ADDRESS: 135 S 18TH ST

Proposal: Install and replace signage

Review Requested: Final Approval

OVERVIEW: This application proposes to replace existing signage at the ground floor and install new signage at the third story.

Building Signage - South 18th Street Elevation - abar Signage (Change in Kind)

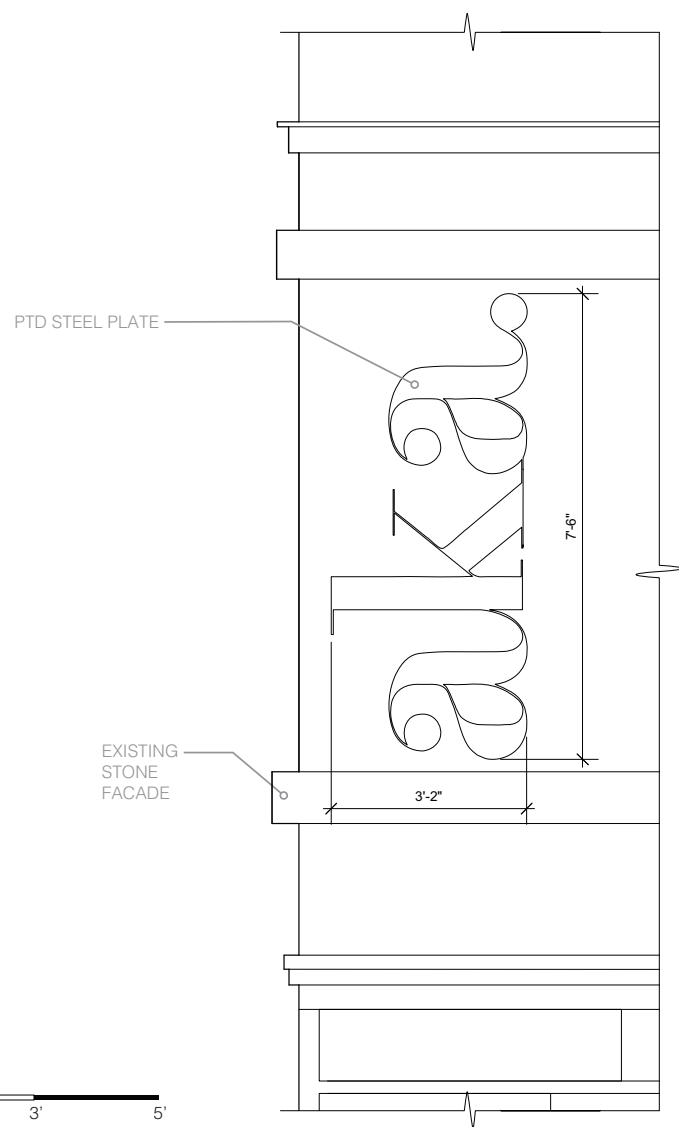
The ground floor signage proposed for replacement would maintain the size and appearance of the existing signage; only the letters would be changed.

AKA BUILDING HOTEL SIGNAGE
Proposed Third Floor Sign - Elevation and Section

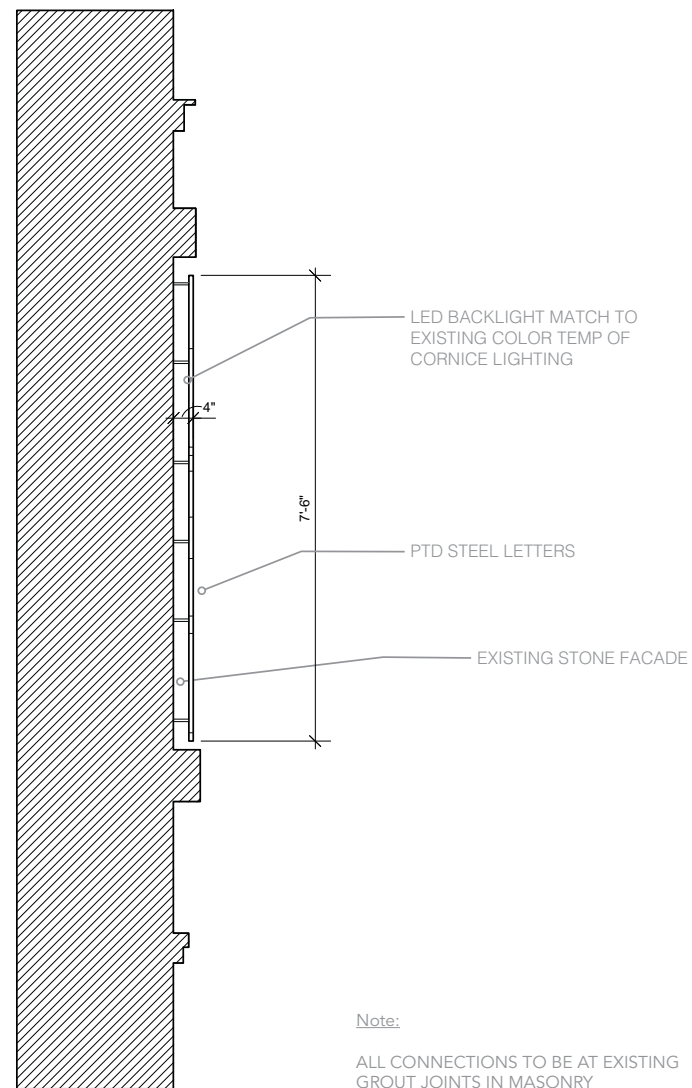
The current application proposes to limit the new signage to the Walnut Street side at the third story. Black painted steel letters with LED backlighting would be installed through the mortar joints.

to locate the attachment points for the sign at grout points to avoid any damage. Ms. Gutterman asked how they were going to get electricity to the sign, because that would have to come through the stone wall. Mr. Lohbauer replied that they would work to minimize any holes or modifications to the stone.

ALL CONNECTIONS TO BE AT EXISTING
GROUT JOINTS IN MASONRY
